# PERMIT

SEWAGE DISPOSAL SYSTEM

ADDRESS 10333 Night Mist Court, Columbia, Md. 21044 PHONE 730-1770

TITLE			
SURVEY & PERCOLATION TEST PLAT			
PROJECT			
FENSKE PROPERTY			
LOCATION			
5TH ELECTION DIST. HOWARD CO., MD			
DATE	DES. BY:	DRAWN BY	CHECKED BY
8-1-78		DMR	WGH
SCALE	JOB NO.	DRWG NO.	
1" = 100'	7717	1041

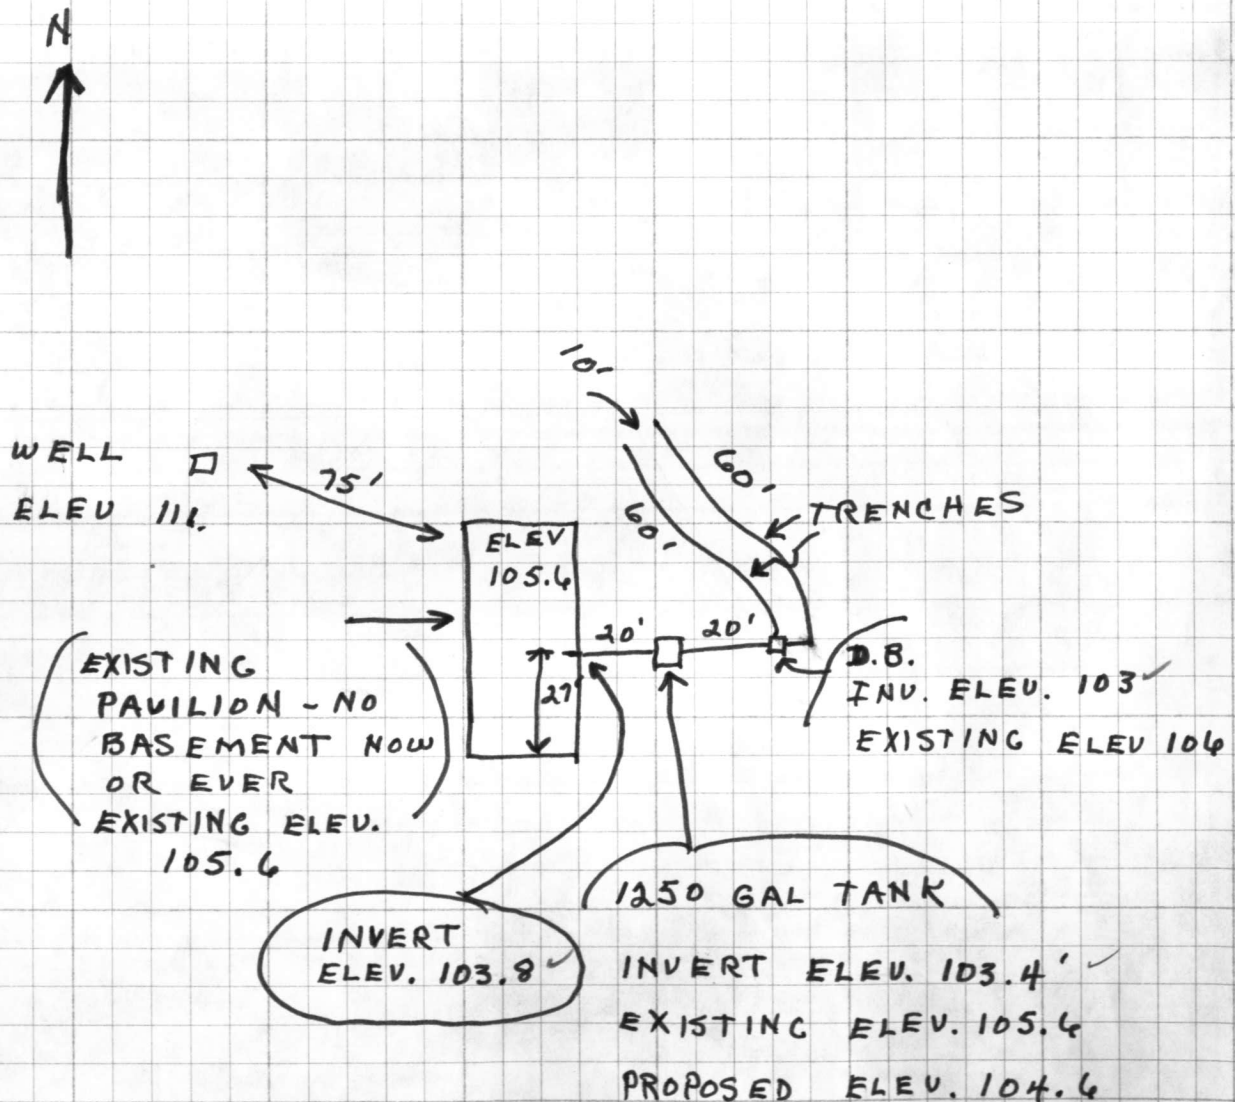
REMARKS 10/9/78 { No pipe in from house to trench; ok for stones in trenches - partial only. No septic tanks this

13 Oct 78 - OK to backfill system. CALL for final when house connection installed (GLK)

25 Oct 78 - House connection made (GLK)

DATE SYSTEM APPROVED 25 Oct 78 INSPECTOR G. Keller

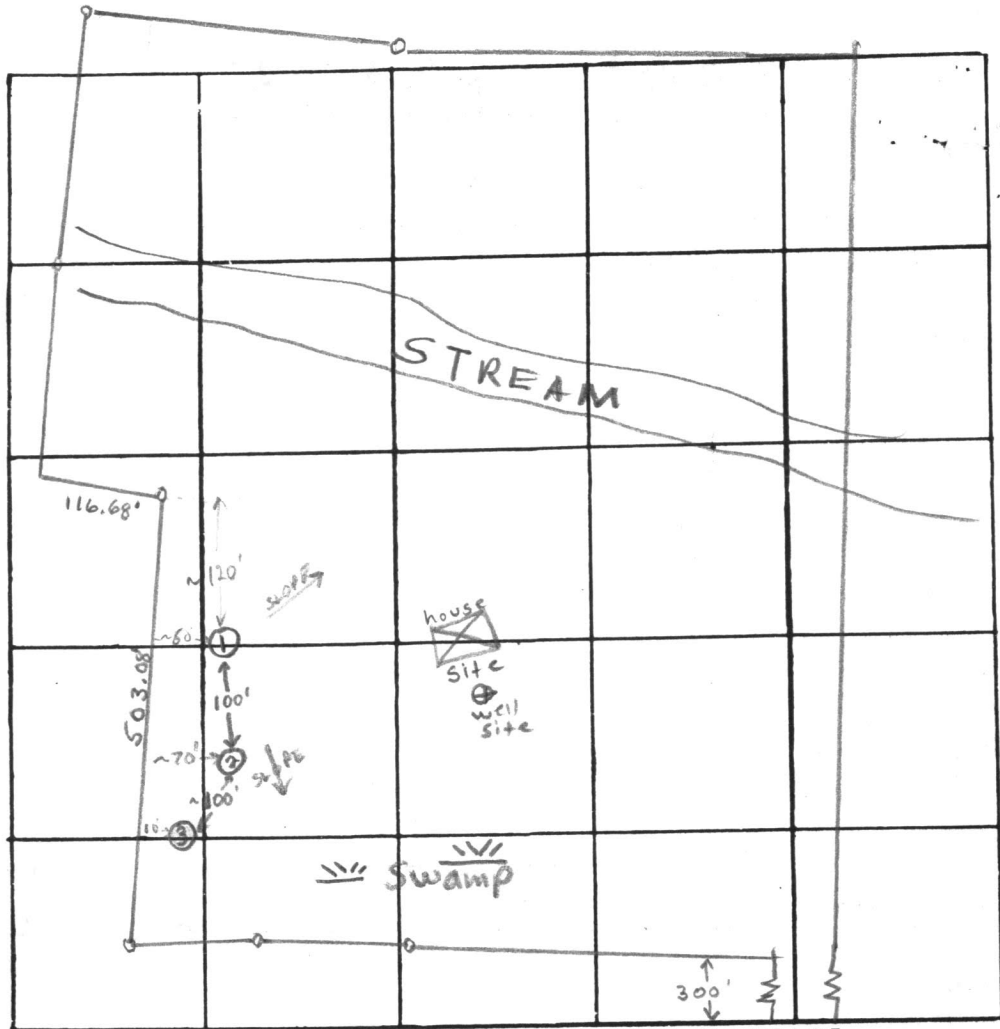
REJECTED BY Frank Skinner FOR any in area tested DATE 3/17/77

REASONS FOR REJECTION OR HOLDING Underground water at 10-12' below grade in area tested F. Skinner

REMARKS This lot fails per test in area tested F.S.

TYPE OF SOIL silty mica loam below top 4-5' clay Water 10-12'
